**PROJECT:** CASTRO COUNTY JAIL  
1004 E. BEDFORD STREET  
DIMMITT, TEXAS 79027

**DATE ISSUED:** DECEMBER 1, 2017

ADDENDUM NO. 1

CASTRO COUNTY JAIL  
DIMMITT, TEXAS

Locker Schedule:

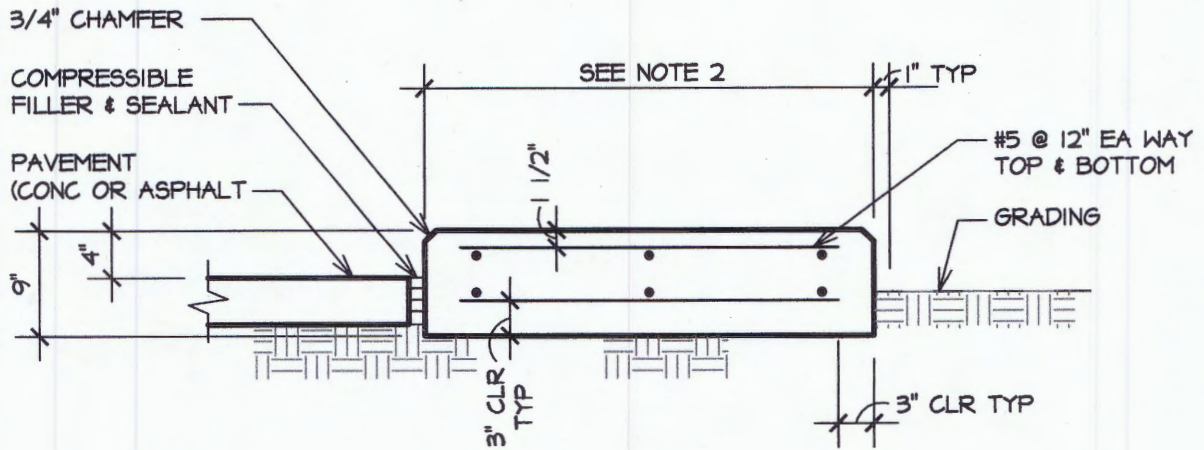
- A. At the Locker Schedule, add personal property lockers in Vestibule 002, as indicated on Attachment No. 1.
